Earraghail Renewable Energy Development

Additional Environmental Information (AEI)

November 2023

Extract from Drawing EAR-SH_L-113: Transponder Activation Zone in elevation

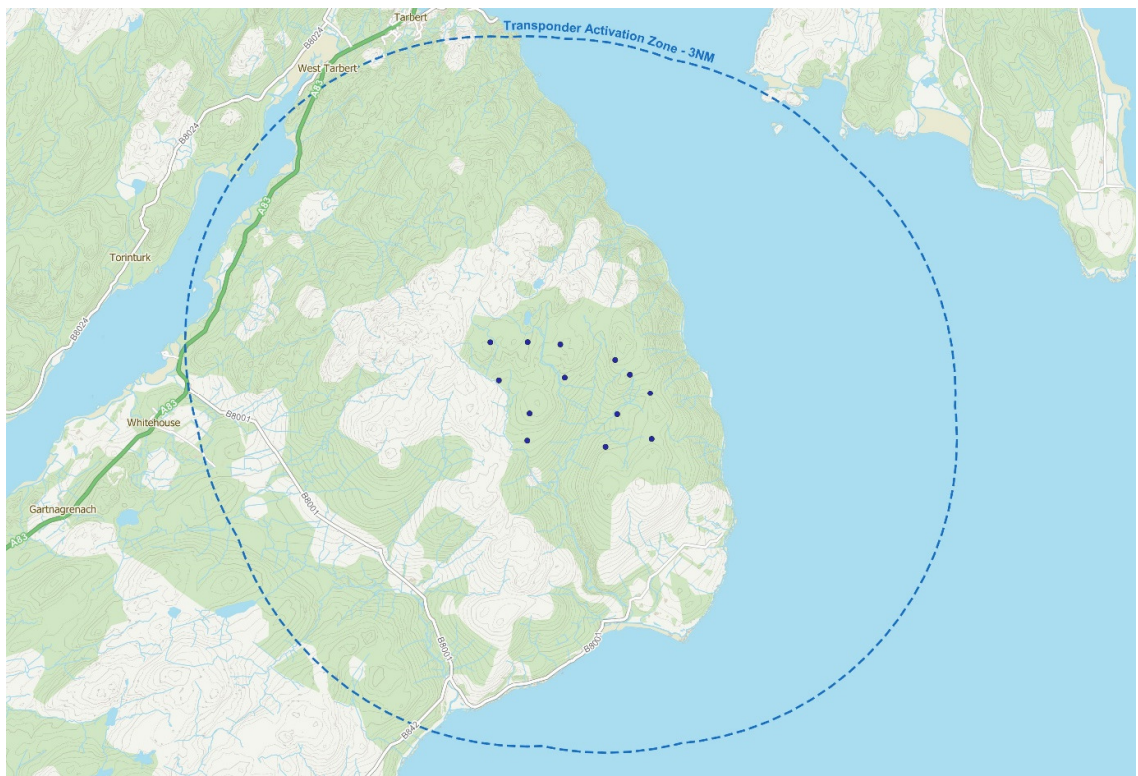
By implementing ADLS, the lighting as outlined above, would only be visible at night when an aircraft was flying directly overhead or within 3 nautical miles (5.556 km) of the boundary of the site at a height of 2700ft or below. Given the height of the turbines and topography of the area, this height is also considered the minimum safety altitude for an aircraft. A minimum safety altitude is determined by a pilot prior to flight to ensure avoidance of collision and safe flight practice is being observed. As a result, it is likely that the only time an aircraft would be flying below 2700ft (thus triggering the ADLS and turning on the turbine lights) would be when an aircraft is in danger by flying dangerously low or carrying out SAR operations. This is referred to as the Transponder Activation Zone within this document and has been illustrated in Drawing EAR-SH_L-113 and included in **Appendix 2**. Further details on the regulatory change required to implement a Transponder Mandatory Zone (TMZ) are provided in **Section 3.2.5**.
